This sheet transmits Revision 2 to SB525B-34-40, which:

NAVIGATION - GARMIN HARDWARE AND SOFTWARE UPDATE TO VERSION 4.8.9

525B (CJ3+)

SB525B-34-40
Page 1 of 30

Figure 1. Wiring Modification (Sheet 1)

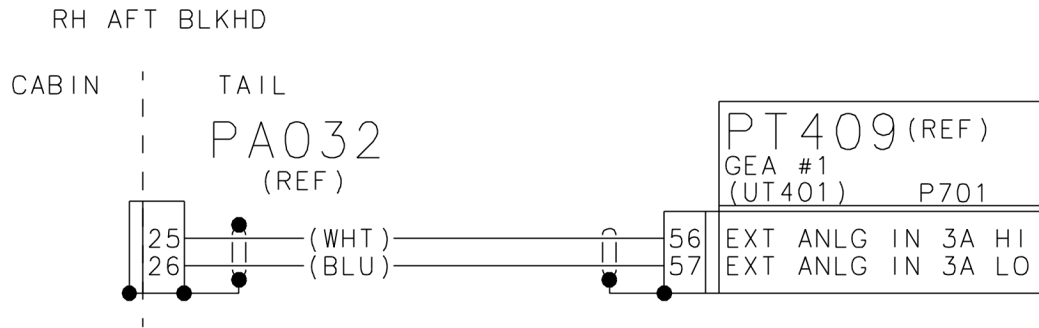
- B. (Airplanes equipped with the Stormscope option) (Refer to Figure 1, Sheet 1.) Modify the wiring.
 - (1) Open the left nose baggage compartment door.

- (5) Remove the PN836 electrical connector from the Stormscope Processor.
 - (6) Remove the PN409 electrical connector from the left avionics pallet.
 - (7) Install the 26PN836-77PN409 Electrical Wire with two M39029/58-362 Connector Pins.

- (8) Install the 77J3-70P606 Electrical Wire using two M39029/58-362 Connector Pins.
 - (9) Install the PN836 Electrical Connector in the Stormscope Processor.

Figure 1. Wiring Modification (Sheet 2)

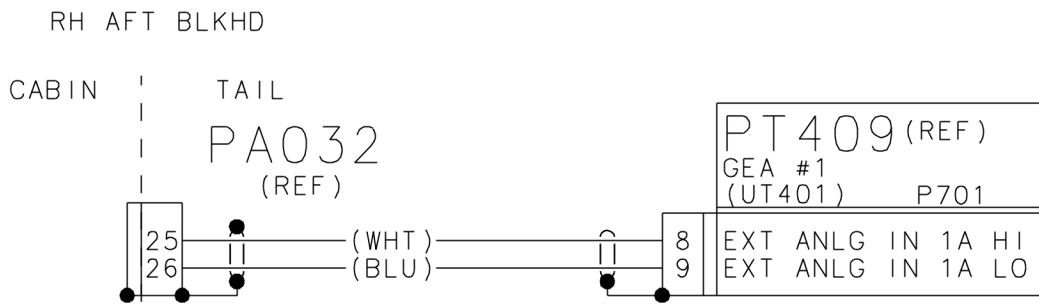
- B. (Refer to Figure 1, Sheet 2.) Do the Oxygen Pressure wiring modification. (Refer to the Citation Standard Practices Manual, Chapter 20, Splices, Terminals and Heat Shrinkable Tubing - Maintenance Practices.)

- (1) Remove the electrical wires from pins 56PT409 and 57PT409 and repin in 8PT409 and 9PT409.
- C. (Refer to Figure 1, Sheet 4.) Install the 011-00979-03 Configuration Modules in the PT407 and PT408 Connector. (Refer to the Citation Standard Practices Manual, Chapter 20, Splices, Terminals and Heat Shrinkable Tubing - Maintenance Practices.)

Figure 1. Wiring Modification (Sheet 3)

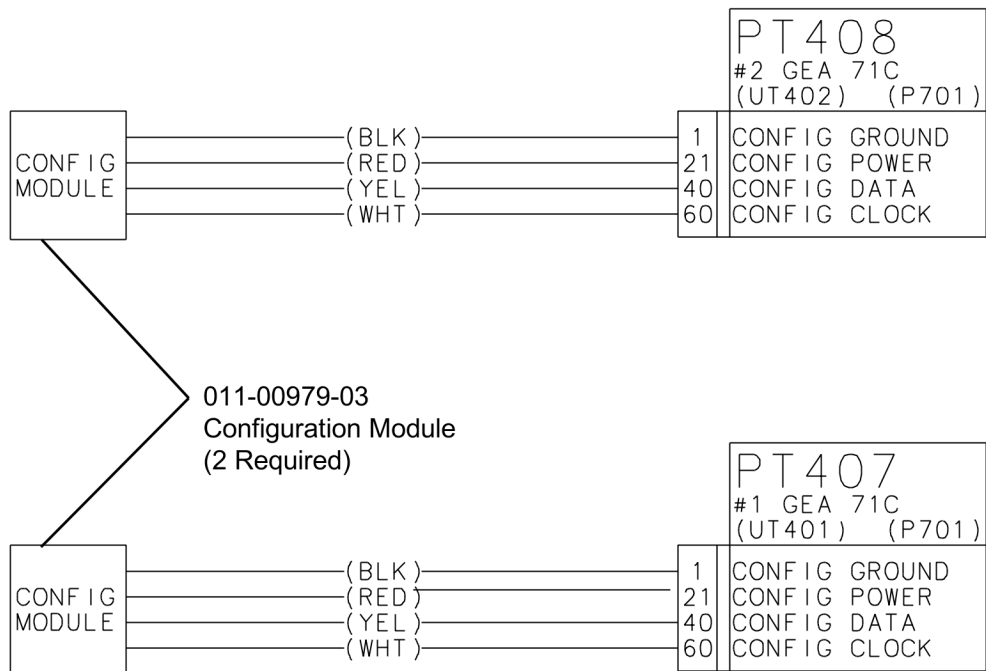
- B. (Refer to Figure 1, Sheet 3.) Do the DME Option Wiring Modification. (Refer to the Citation Standard Practices Manual, Chapter 20, Splices, Terminals and Heat Shrinkable Tubing - Maintenance Practices.)

- (1) Remove the electrical wire from pins 74PI548 and 75PI548 and install in pins 31PI548 and 52PI548.
 - (2) Remove the electrical wire from pins 15PI523 and 16PI523 and install in pins 54PI523 and 55PI523.

Figure 1. Wiring Modification (Sheet 4)

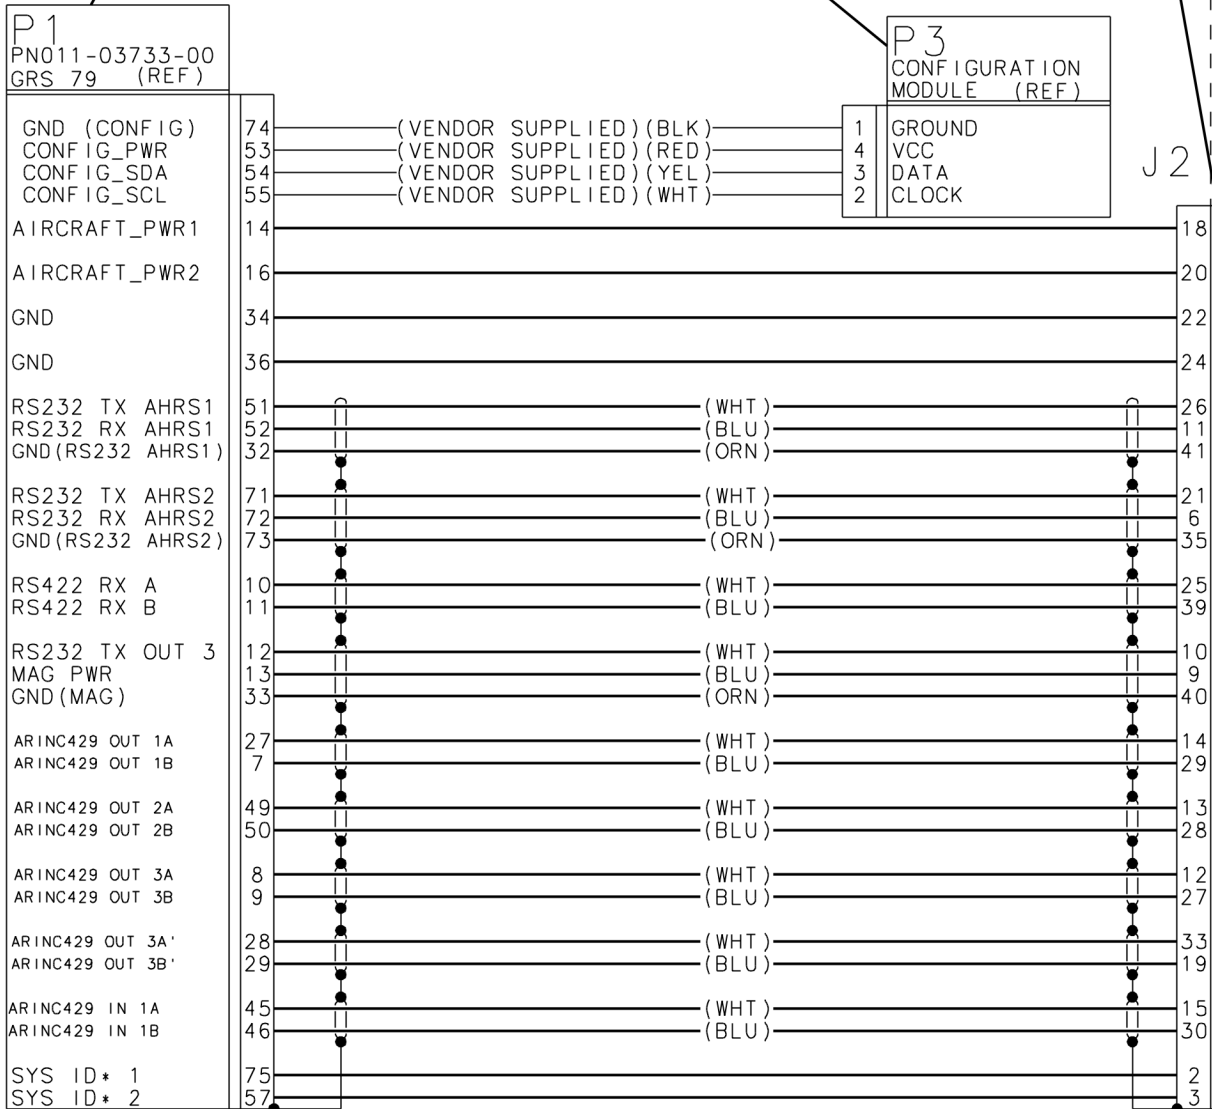
- (1) Install the 011-00979-03 Configuration Module in the PT407 Connector.
- (2) Install the 011-00979-03 Configuration Module in the PT408 Connector.
- D. Install the new 011-03682-04 GEA 71C Engine Interface Units. (Refer to the Model 525B Maintenance Manual, Chapter 77, Garmin GEA 71C/71H Engine/Airframe Interface Unit - Removal/Installation (Airplanes -0057 and -0451 and On.))

Figure 1. Wiring Modification (Sheet 5)

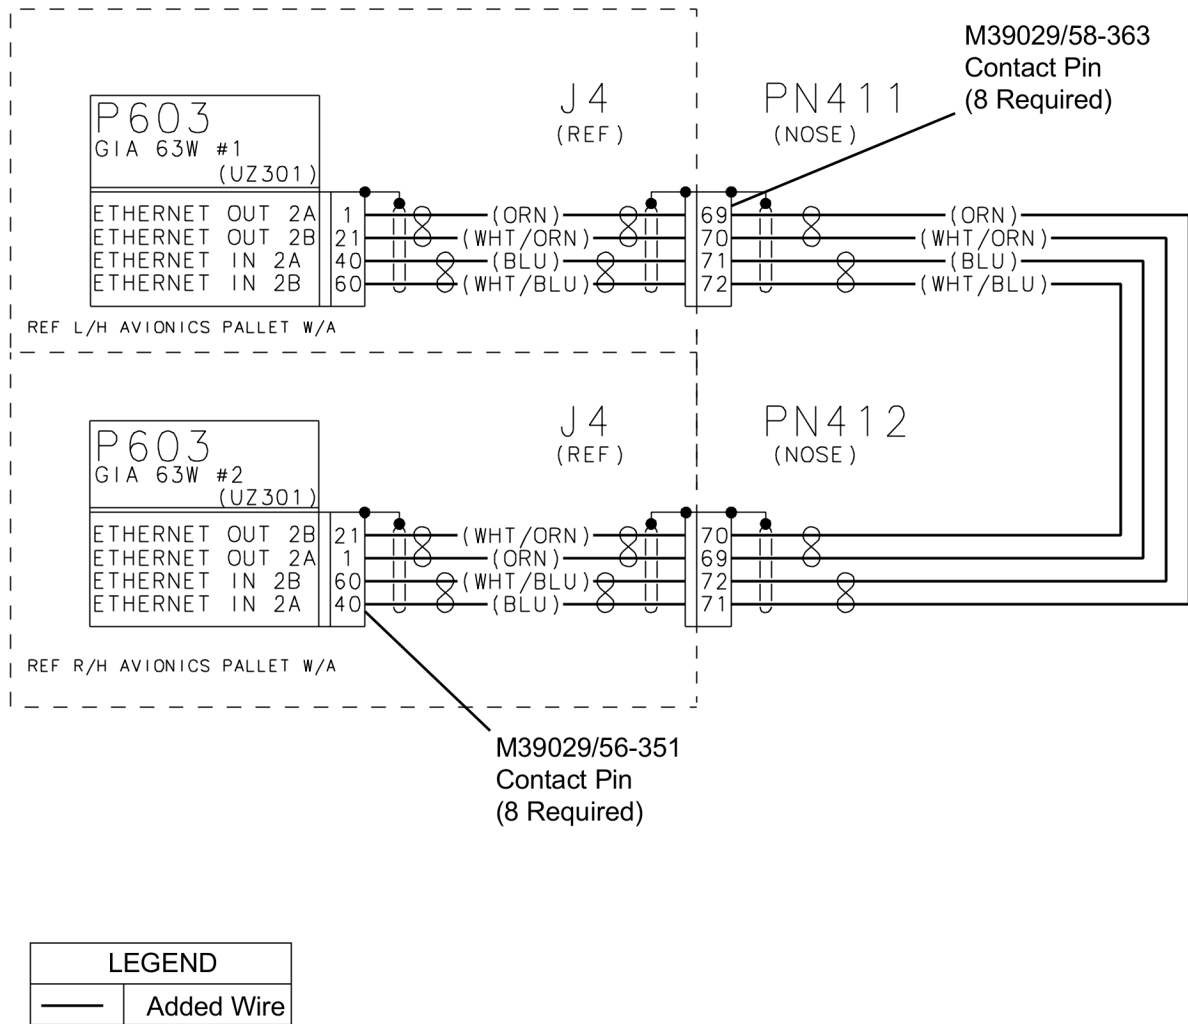
- B. (Refer to Figure 1, Sheet 5.) Do the GRS79 Jumper Wiring Modification. (Refer to the Citation Standard Practices Manual, Chapter 20, Splices, Terminals and Heat Shrinkable Tubing - Maintenance Practices.)

NOTE: It will be necessary to assemble two GRS79 Jumper Wiring Modifications. One for each GRS 79 AHRS Units

Figure 1. Wiring Modification (Sheet 6)

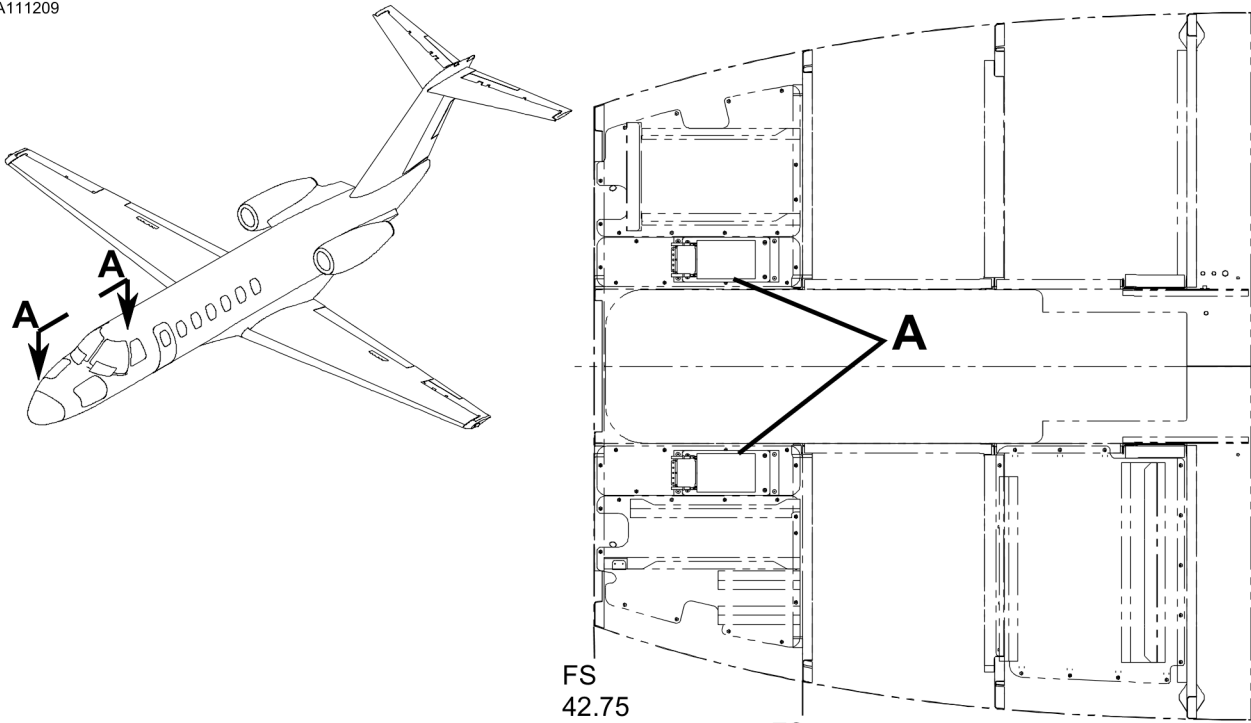
- (12) Engage the NAV IAU 1 circuit breaker located on the right circuit breaker panel in the cockpit.
 - C. (Refer to Figure 1, Sheet 6.) Do the GIA 64E Wiring Modification. (Refer to the Citation Standard Practices Manual, Chapter 20, Splices, Terminals and Heat Shrinkable Tubing - Maintenance Practices.)

- (1) Install the 1P603-69J4 (ORN), 21P603-70J4 (WHT/ORN), 40P603-71J4 (BLU), 60P603-72J4 (WHT/BLU)] Ethernet Cable with four M39029/56-351 Contacts, four M39029/58-363 Contact Pins and two S2974-8 Shield Terminations.

- (2) Install the 21P603-70J4 (WHT/ORN), 1P603-69J4 (ORN), 60P603-72J4 (WHT/BLU), 40P603-71J4 (BLU) Ethernet Cable with four M39029/56-351 Contacts, four M39029/58-363 Contact Pins and two S2974-8 Shield Terminations.

Figure 2. AHRS Remote Rack Installation (Sheet 1)

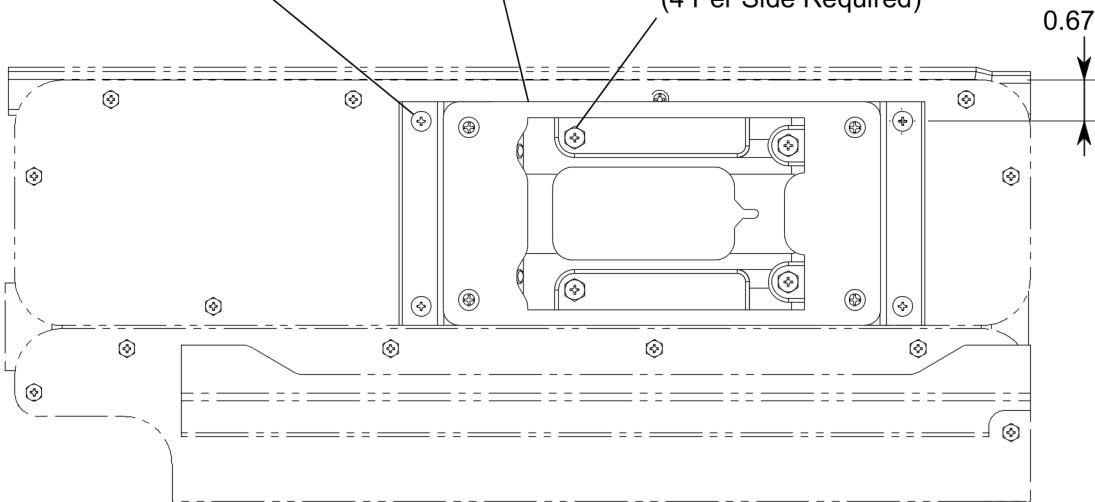
- C. (Refer to Figure 2, Detail A and View A-A.) Install two new 117-00608-00 GRS 79 Remote Racks.
 - (1) Remove and keep the MS27039-0808 Screws from the two 115-00459-00 GRS 77 Mounting Racks.

- (2) Remove and discard the two 115-00459-00 GRS 77 Mounting Racks.
 - (3) Install two 6397107-2 Channel Assemblies for each 117-00608-00 GRS 79 Remote Rack installation with the kept MS27039-0808 Screws.
